Re: Abengoa Mojave Solar Project (09-AFC-5): Written Response to Data Request Set 1B (nos. 1-86)

Application for Certification for the)
ABENGOA MOJAVE SOLAR POWER PLANT) Docket No. 09-AFC-5
)
)
_____)

Table of Contents	1
Cultural Resources (1-20)	2
Soils and Water Resources (21-61)	8
Visual Resources (62-71)	20
Visual Resources – Visual Plume (72-77)	31

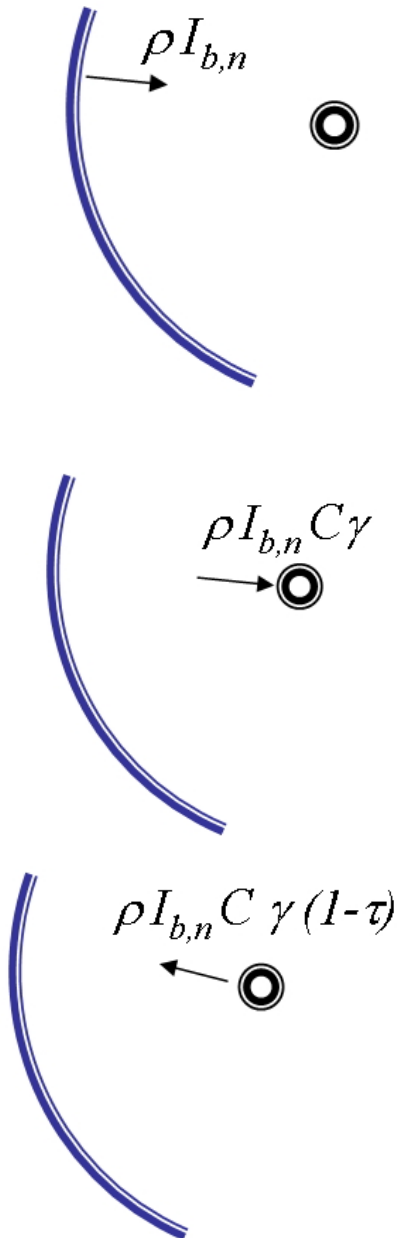
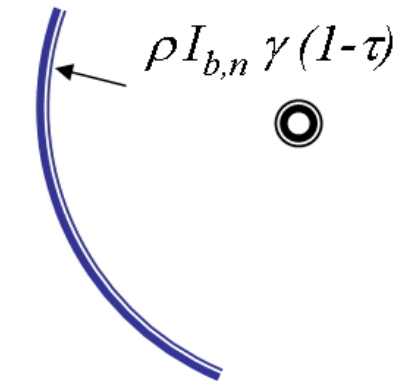
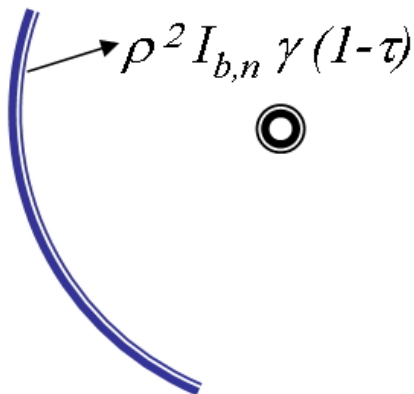
Please characterize the maximum potential brightness (luminance) of diffuse and spread reflection from mirrors in candela per square meter.

As is shown in the Response to Item 72, the focal point constitutes the point for maximum concentration of solar radiation. Any rays that miss the receiver will be spread out with decreased concentration as the distance from the collector increases.

There are two hypothesized situations of potential brightness emanating from the collector. The first is a direct reflection of sunlight off of an SCE mirror back to an observer. This situation is not expected due to the singularly-curved specular surface reducing distant images to a line when viewed by an observer.

This radiation is reflected by the mirrors. This reduces the solar radiation by the reflectivity ρ of the mirrors.

The radiation incident on the receiver is obtained by factoring in the concentration ratio C , and the optical intercept γ .

Only a fraction of the incidence radiation is reflected by the receiver. For simplicity, let's assume that no absorption occurs on the receiver glazing, and that a fraction $(1 - \tau)$ is reflected.

The radiation that hits back to the mirror is the reduced by the inverse of the concentration ratio, cancelling out this term.

Finally, the radiation being reflected back from the receiver is affected again by the reflectivity of the mirror.

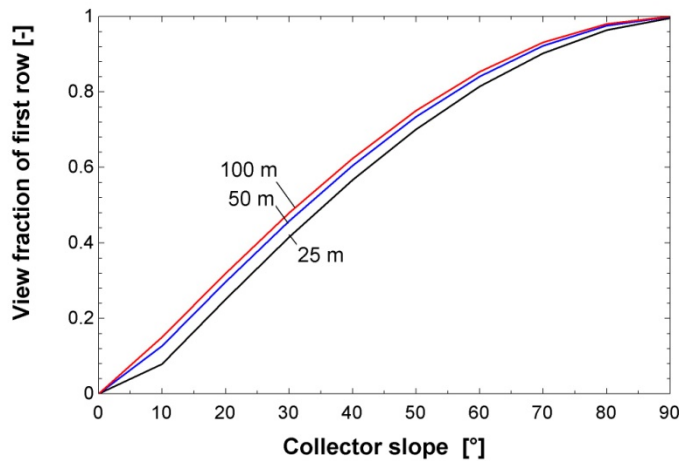
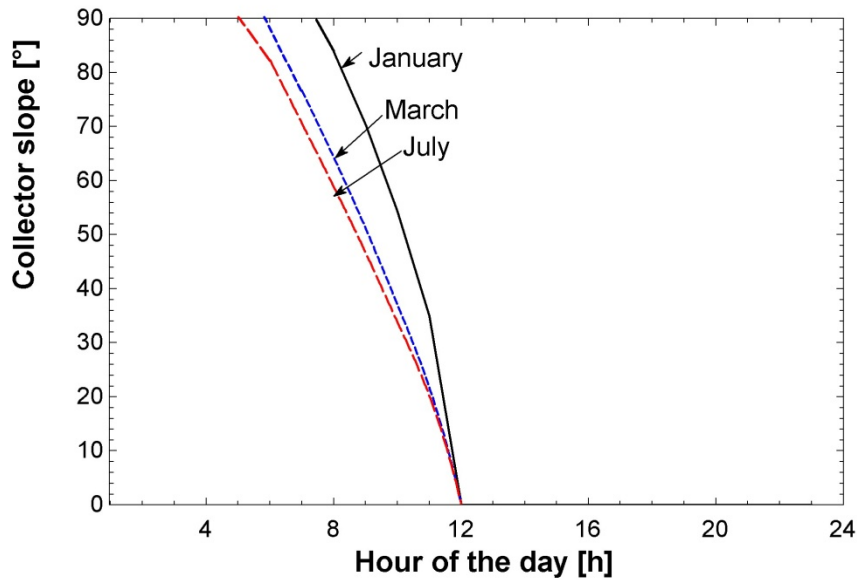
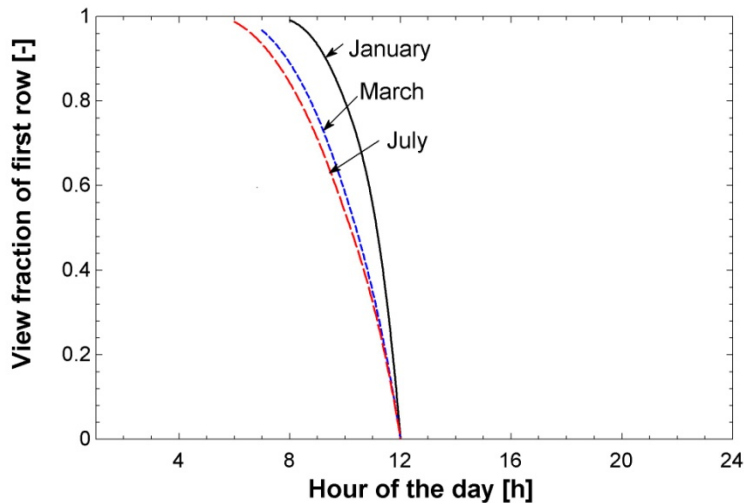
Please describe the hours in which the mirror surface of a trough could be visible to an off-site viewer on the ground, and the proportion of surface visible in the course of the day.

In order to answer this question, the following picture defines the basic geometry of an observer represented by the line AB, at a distance BC from a collector which is in a tilted position described by the slope angle β . The observer's view angle from the horizontal to the center of the collector (O) is described by the angle α .

An analysis was performed in order to evaluate the mirror surface visible to an observer at a distance BC from the collector. The following figure shows the mirror surface visible to an observer at different collector slope angles. Three distances from the collector were evaluated: 25m, 50m and 100m, which show very similar behavior. The vertical axis in this plot is presented as the non-dimensional visible surface area, calculated as the ratio between the visible area to the aperture of the collector.

The second step was to calculate the hourly collector slope for the entire year. The following figure shows the monthly average collector slope, for January, March and July, as function of hour of the day. For this plot, only the values of slope when the collector face east are plotted, indicating the slope for the time of the day in which some part of the mirror surface is visible. This plot shows how the sunrise is earlier in July than in January, as well as it shows a much faster movement of the collector during winter, going from a slope of 90° to zero in fewer hours than in July.

Finally, the two functions (the fraction of visible mirror surface as function of collector slope and the slope as function of hour of the day) were combined into a single figure. The following figure shows the fraction of the mirror surface visible to an observer at 100 meters from the collector, as function of hour of the day.

This plot indicates that an observer located on the east side of the collector field will see a fraction of the collector surface from sunrise to noon. However, this fraction drops very rapidly during the day. In July, the visible collector surface drops to 50% in 4 hours, while in January it drops to 50% in less than 3 hours.

Figure 1. Illuminated HCE Pictured from Below

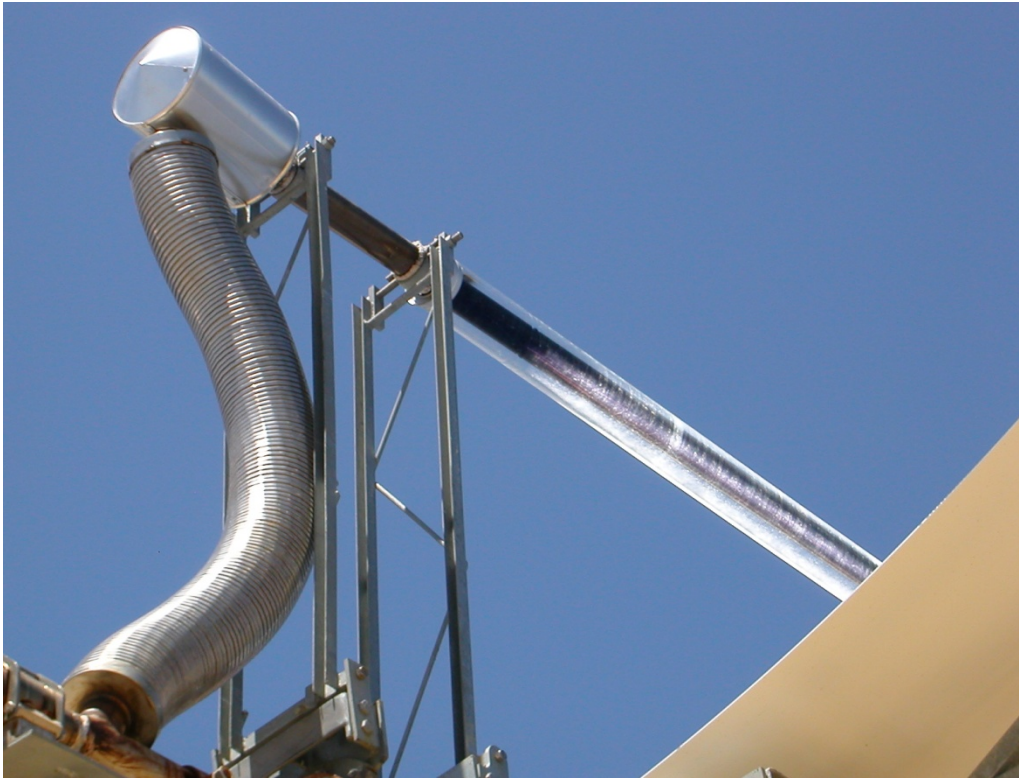
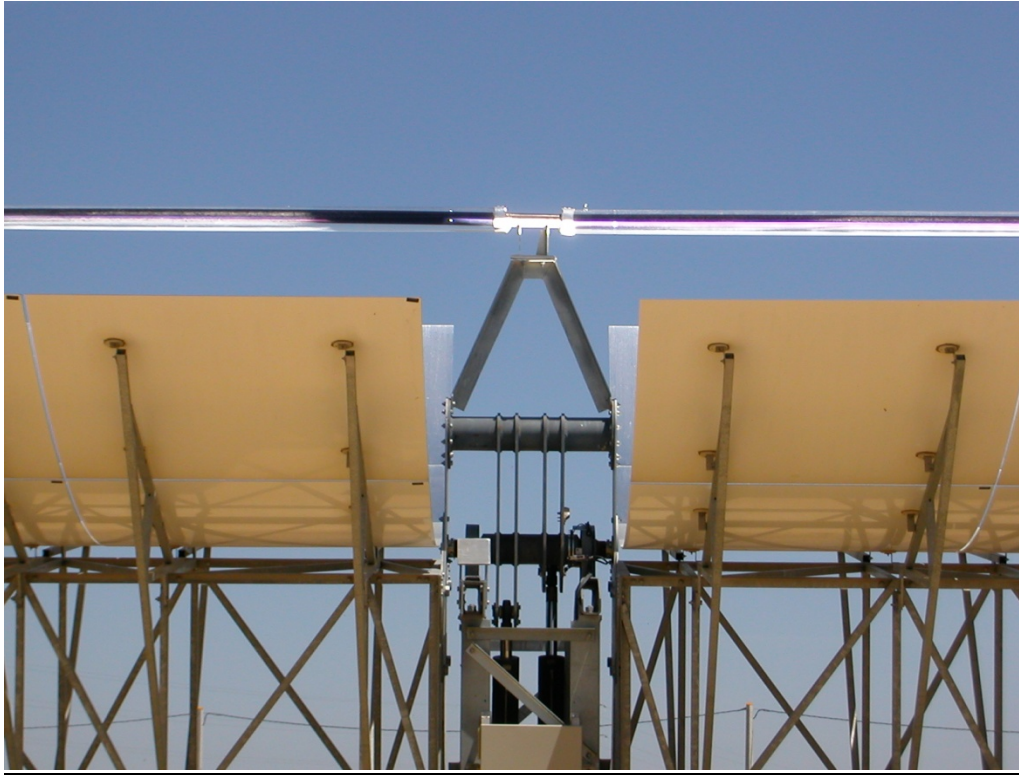
Please provide all available anecdotal information on glare effects of the Kramer Junction and existing Luz Solar Energy Generation System (SEGS) XI and XII power plants to the west and north of the project site, including photographs of off-site diffuse or spread glare, and images of the heated HCEs, as seen from public roads/viewpoints.

Pictures available to the Applicant and taken of the Applicant's project in Sevilla Spain showing with illuminated HCEs are included in Figure 1 and Figure 2 below.

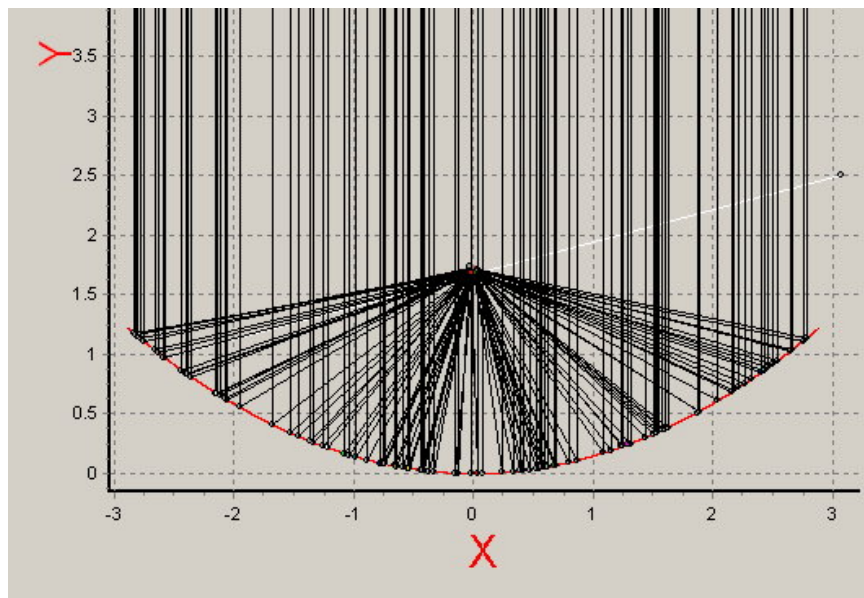
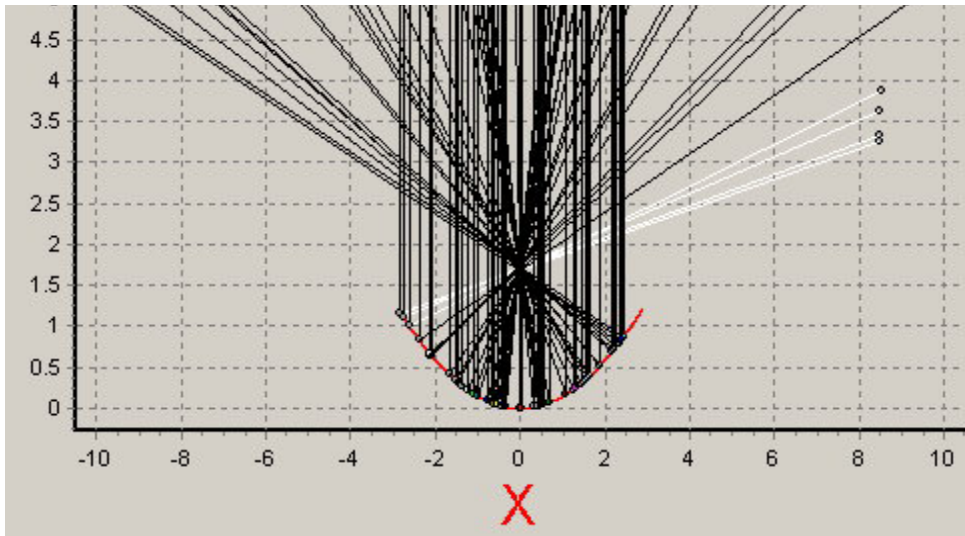
Please explain whether any portion of the directly reflected solar radiation could pass by the HCEs (the steel tube annulus) due to the total divergence factor of the reflectors.

- A. If so, how much?
- B. Is this amount sufficient to cause any potential retinal damage or flash blindness?
- C. Are there measures that would prevent such inadvertent off-site reflection (such as shielding of the HCEs, etc.)?

The following figure shows an example raytracing analysis of the collector. The high concentration of lines on the receiver and the few missed rays demonstrate the high optical accuracy of the collector.

B. The Applicant is not qualified to make judgments better made by an ophthalmologist. Notwithstanding this, the Applicant expects that the answer is no. Only 3% of the energy that hits the mirror misses the receiver. Furthermore, once the radiation misses the focal point (i.e., the receiver), the radiation becomes more and more dispersed. For example, the following figure represents a raytracing analysis without the receiver. The vertical sun rays hit the mirrors and

are reflected towards the focal point. However, once that they pass the focal point, the distance between them grows as they leave the collector. This behavior indicates the behavior of the rays that miss the receiver.

C. There are no practical measures that would prevent such reflection. Any measure that would try to prevent this radiation would result in higher energy being missed by blocking incident radiation.
